### **PUBLIC HEARING III MEMORANDUM**

**528 Boylston Street**

Subject: 528 Boylston Street 40B Design Review (Memo #2)

**Re: Proposed Multifamily Residential Development Transportation Peer Review**

## Current Proposed Streetscape

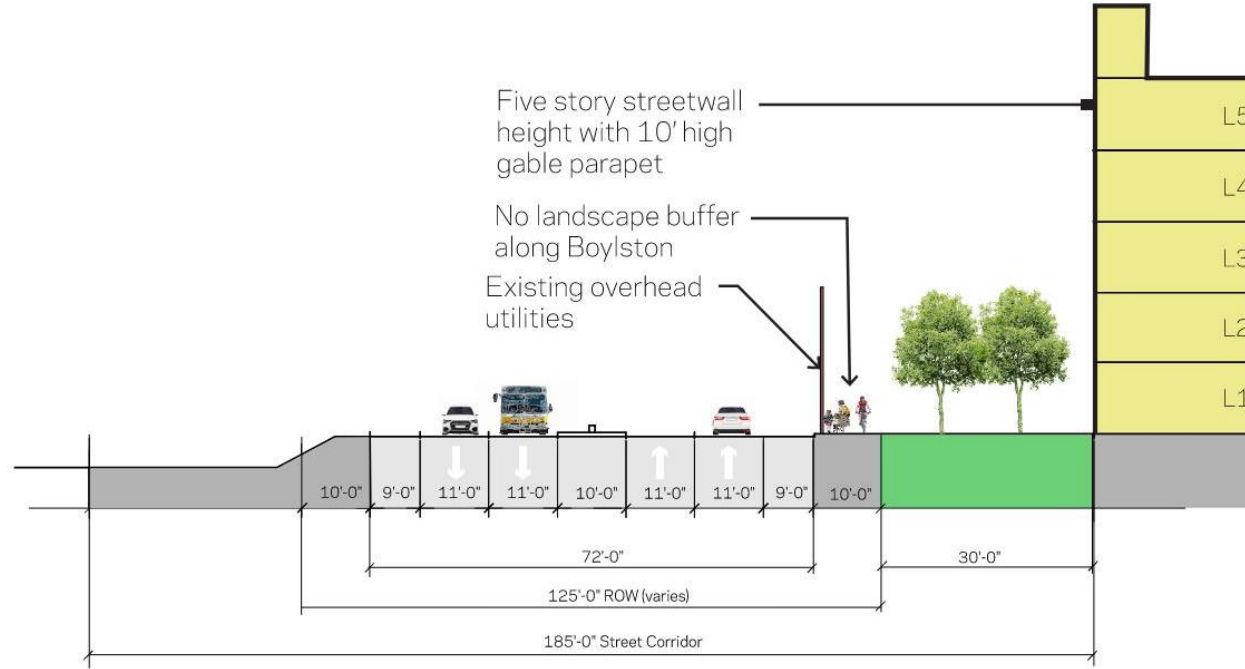
The current conditions for the Boylston Street frontage include a narrow sidewalk with no street trees or pedestrian buffer, overhead utilities, and no ground level activity. The applicant has proposed a wider sidewalk and new landscaping between the sidewalk and the proposed building. While this is an improvement over the existing conditions, we encourage the applicant to consider adding a wide tree-lined landscape buffer along the edge of the street to provide additional screening and protection for pedestrians. We also encourage the applicant to consider burying all overhead utilities.

Potential for undergrounding of overhead utilities if shoulder is expanded along Boylston Street

Tree planting is inconsistent and does not provide a buffer for pedestrians

Sidewalk with no buffer for pedestrians

Highway guard rail provides safety but has negative visual impact

# Boylston Street Frontage

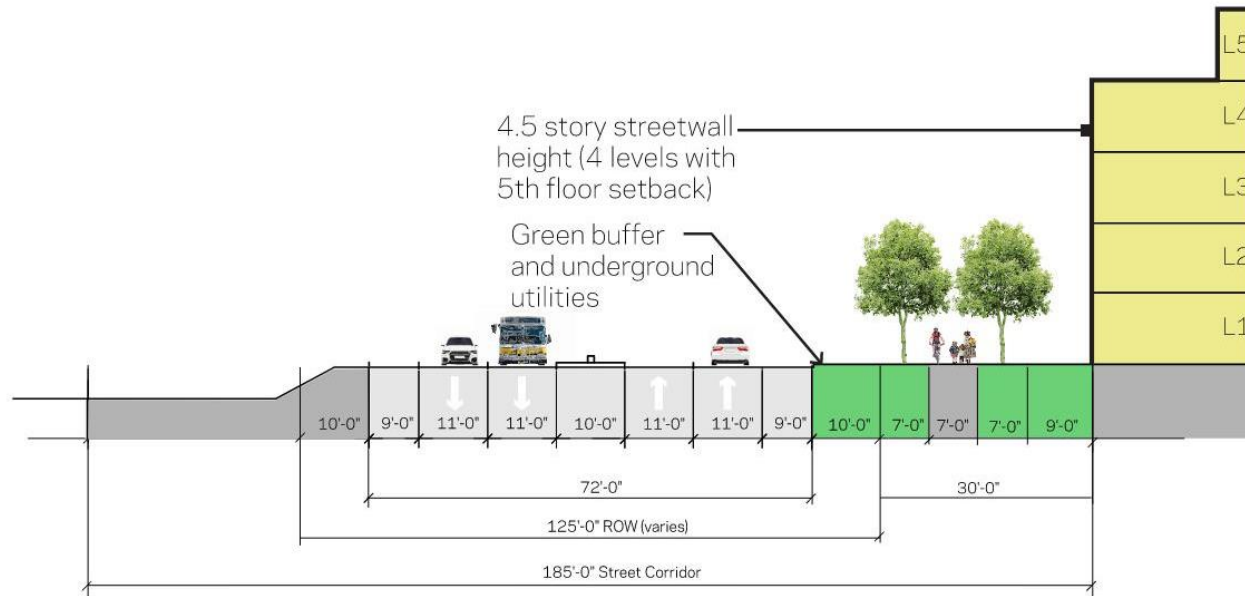
The first plan revision pushed the building further away from Boylston Street, creating opportunities for additional buffering and transitions in massing. The latest revision has now been expanded to include a 30' front yard setback that complies with the required setback in the SR2 zone. While we are encouraged by the expanded front yard setback, we still have concerns about the design of the streetscape along Boylston Street. The latest plans continue to locate the public sidewalk right along the edge of Boylston Street with no buffer or curbside landscaping to protect pedestrians. We continue to encourage the applicant to fully take advantage of the 30' front setback by giving more consideration to the safety and comfort of pedestrians by incorporating a wide planted buffer that physically separates the sidewalk from fast-moving traffic along Boylston Street. Trees could be planted within this buffer (on state and/or private property) to provide shade and physical protection for pedestrians. If a guard rail must be included as part of the streetscape design, we recommend that the applicant explore design alternatives that blend in with the surroundings (ex: Corten model with weathered steel that rusts to a natural, more subdued finish compared to galvanized steel more commonly used). Stone walls and landscape berms could also be included to offer buffering and to blend in with the natural environment. Moving a narrower sidewalk (5'-7') back from the street with a planted buffer would be preferable to building an overly wide sidewalk (10') along Boylston Street, which creates more impervious surfaces and more runoff. [\[see pages 6-8 in attached document\]](#)

# Boylston Street Massing

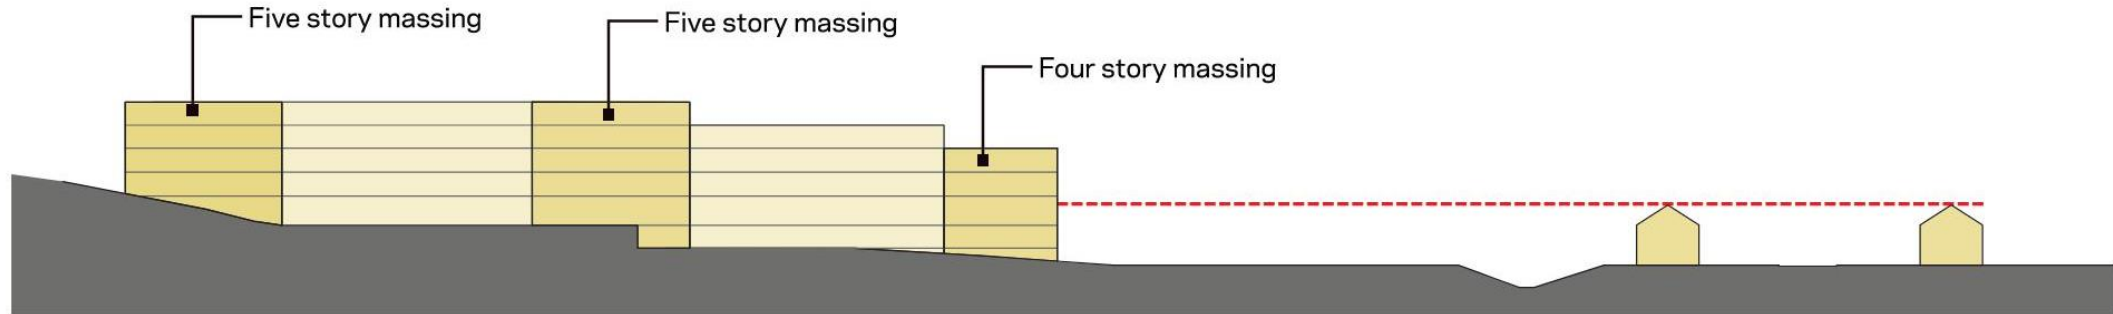
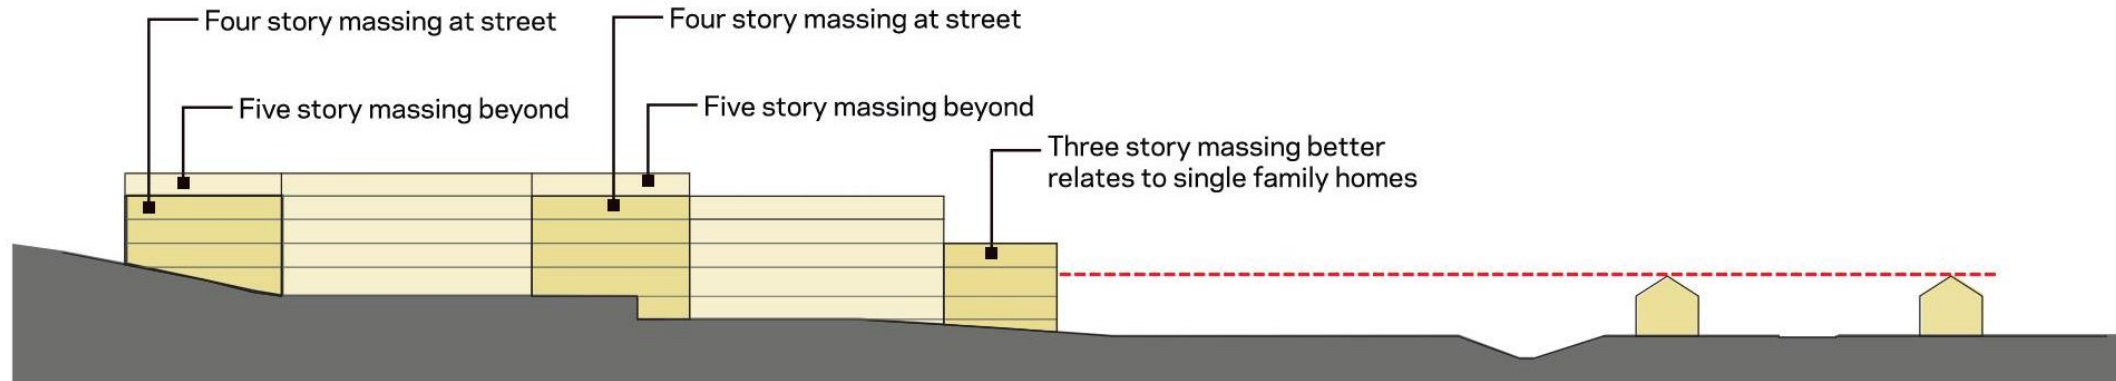
1. A maximum façade elevation along Boylston that does not exceed the maximum Village Center 3 (VC-3) height of 4.5 stories. This could be accomplished by stepping back the top level of the building or changing the profile of the roofline, particularly for the wings that extend closer to the street. [\[see pages 9-14 in attached document\]](#)

2. Consider stepping down the Boylston Street massing further as it steps down the hill on the east side, perhaps down to a 3-story elevation. This could help transition the height of the building to better relate to abutting single family houses on Olde Field Road. [\[see pages 9-10 in attached document\]](#)

# Bicycle Access

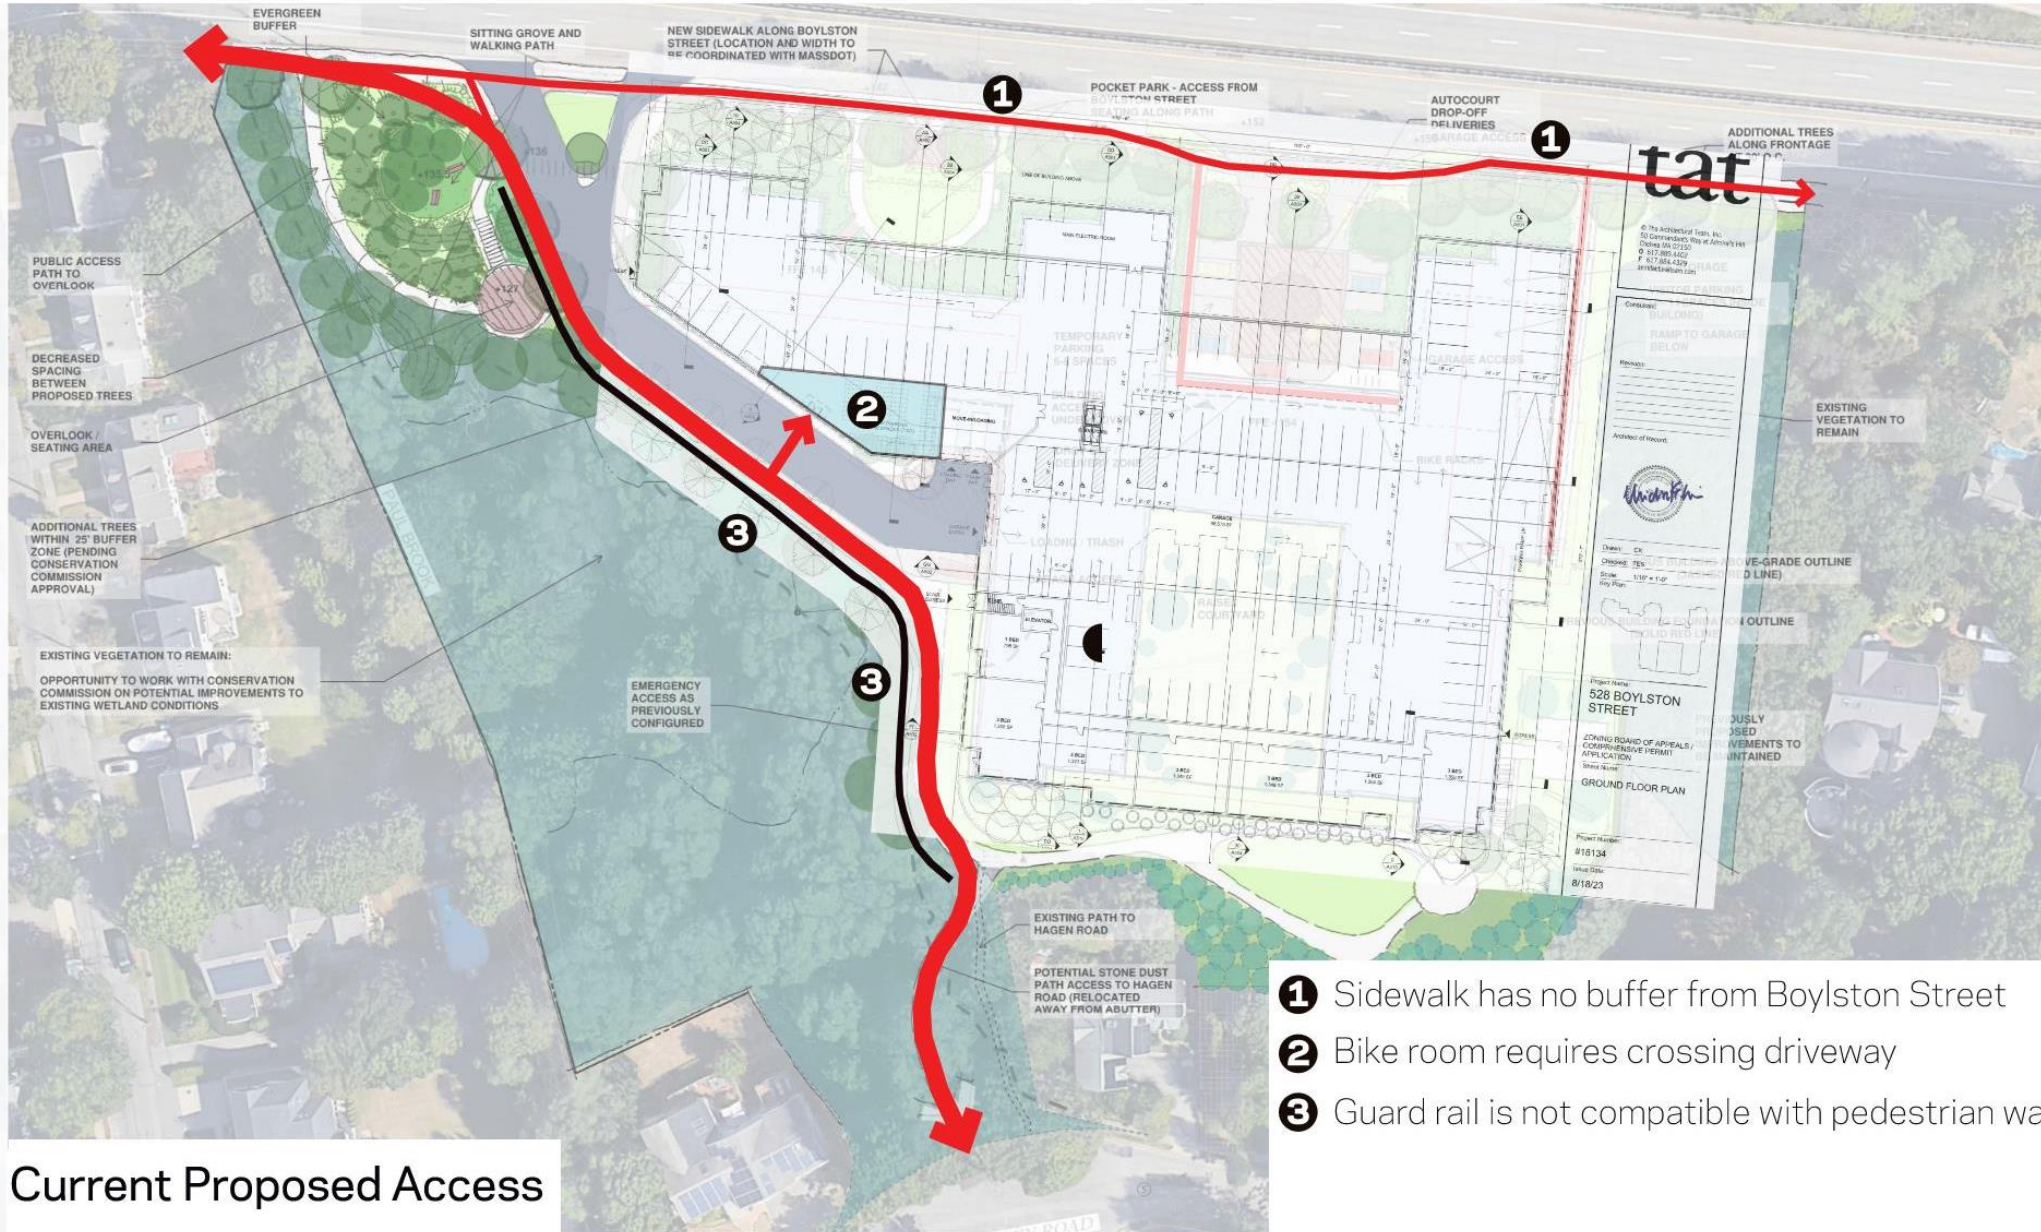
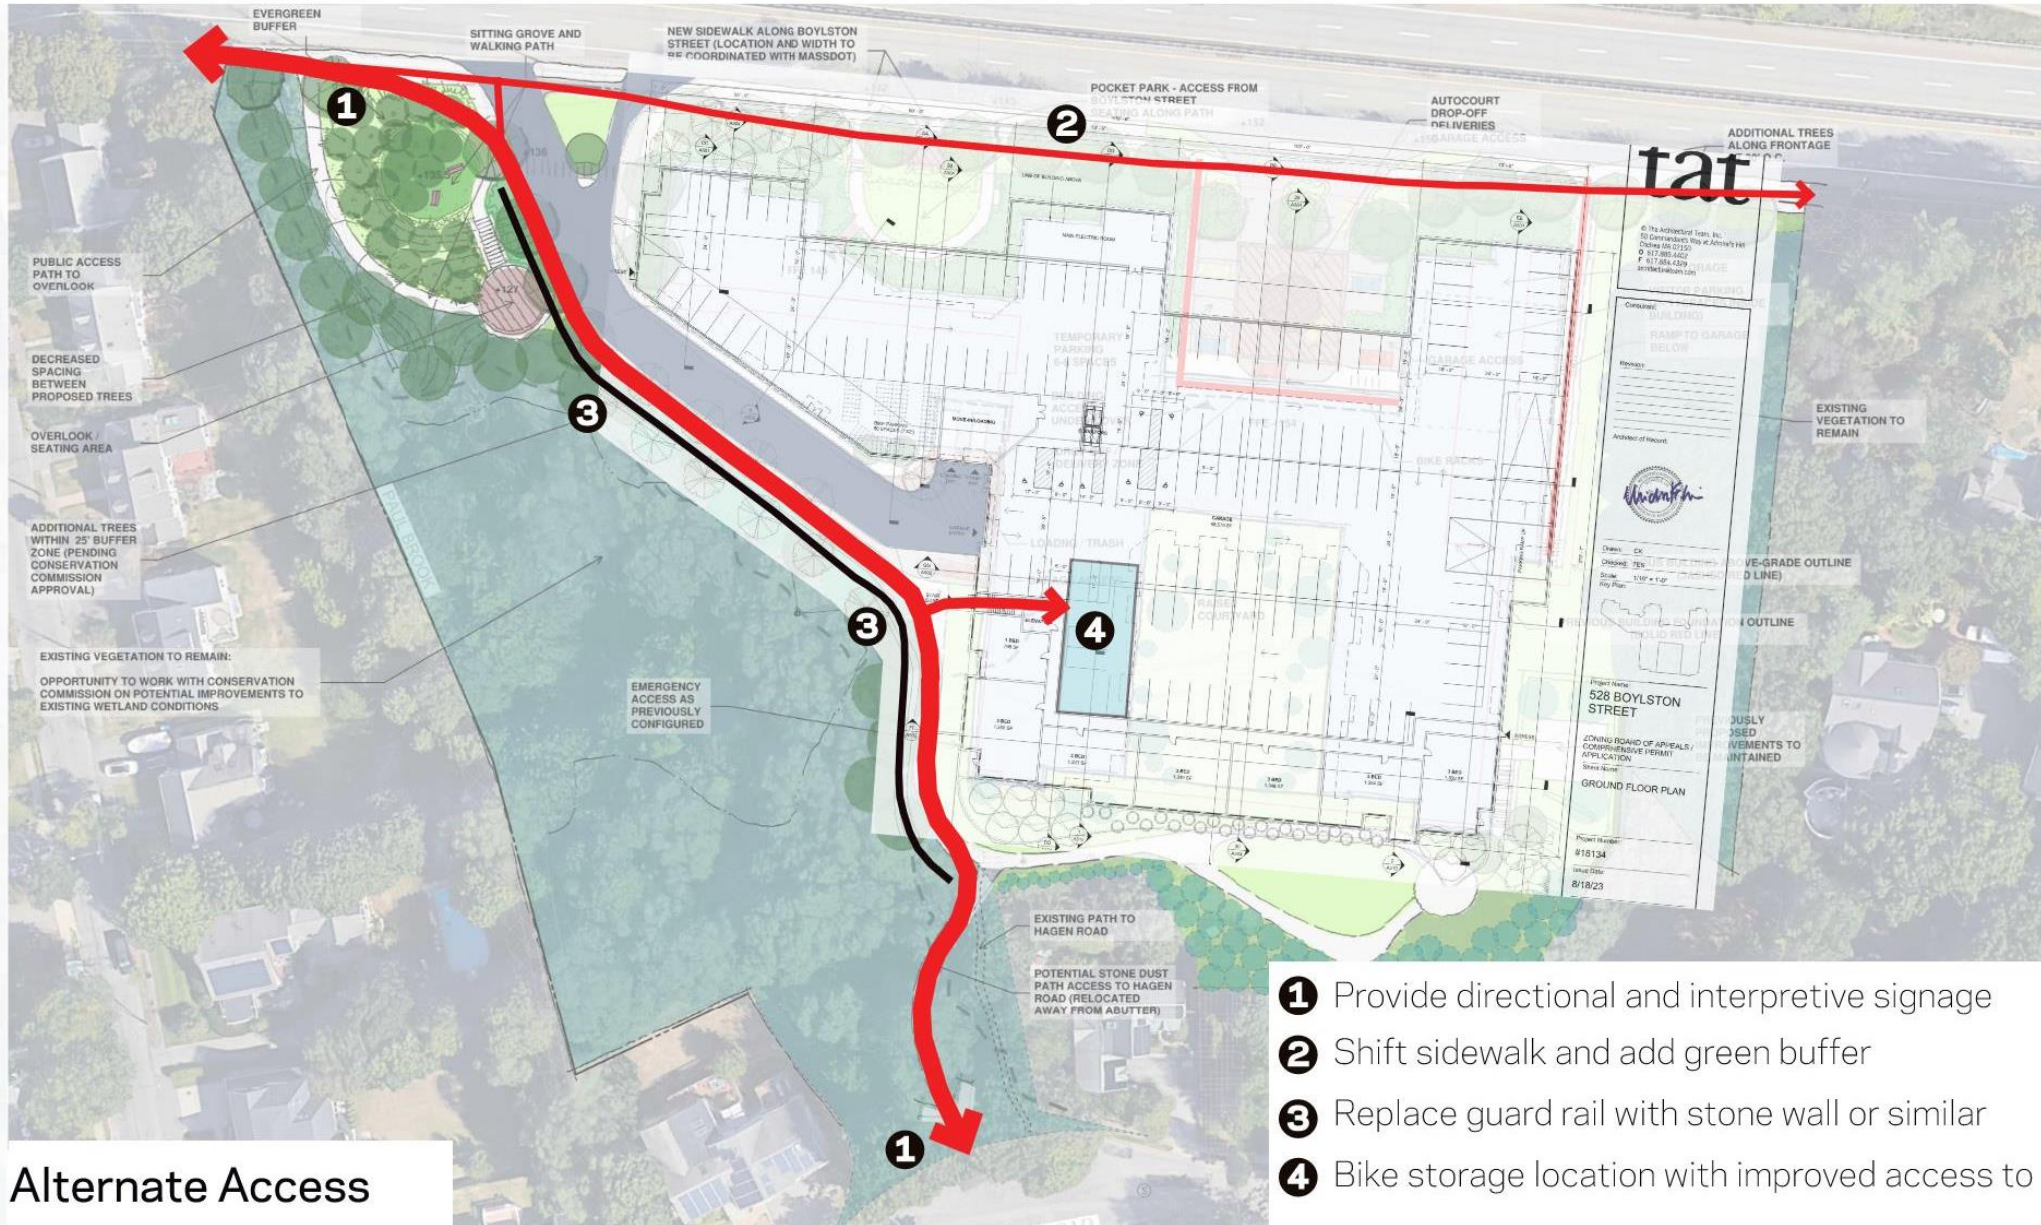
We are pleased to see the relocation of the bike room to the west side of the building, as this will provide more convenience for most riders who will be arriving from the west or conversely from the south on Hagen Road. However, the proposed entrance to the bike room requires bicyclists to cross the proposed service drive and to travel through the garage to reach the elevator. We strongly recommend that the entrance and bike room be shifted further south near the other public entrance at the southwest corner of the building. This access point will offer more convenient access that will avoid any potential vehicular conflicts and provide direct access to an elevator. [see pages 15-16 in attached document]

- 1 Provide directional and interpretive signage
- 2 Shift sidewalk and add green buffer
- 3 Replace guard rail with stone wall or similar
- 4 Bike storage location with improved access to path
